City of Edina

RE: Plan Revisions – per Approved Plan Conditions (Resolution No. 2018-55)
Sienna on the Park - Pentagon North Housing Redevelopment

July 9, 2018

Figure 1:

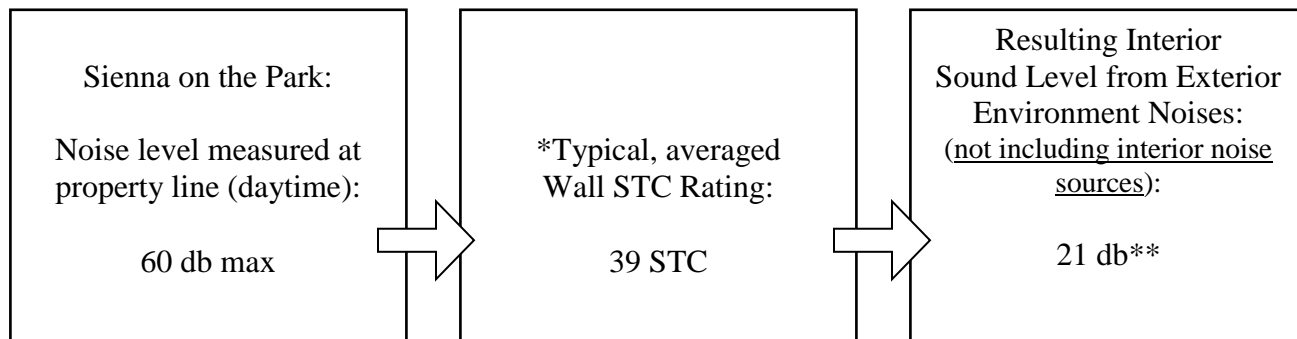
Investigate and provide mitigation measures to address the state law requirements for noise in regards to the Seagate operation to the South.

Due to the nature of 5-story construction, current energy code, details and our high quality exterior materials, the buildings will have high STC-rated wall types and resulting high sound attenuation to mitigate surrounding noise.

These factors combine to inherently meet or exceed the EPA's 45 db interior, residential sound criteria in mitigating exterior noise sources.

The property has typical, urban noise levels primarily generated from 77th Street traffic. As measured by City staff, outside daytime noise along the property line and 77th Street average between 55-60 decibels. These numbers are similar to our team's findings. This is acceptable within the Noise Area Classification 1 (Residential) noise limits of 60 and 65 db.

**Average wall STC per HUD: 2x4 framing (project is 2x6), 16 in o.c., 3.5" insulation (project is 5.5" insulation), interior gypsum wall board, exterior sheathing, incl. 25-30% openings/windows.*
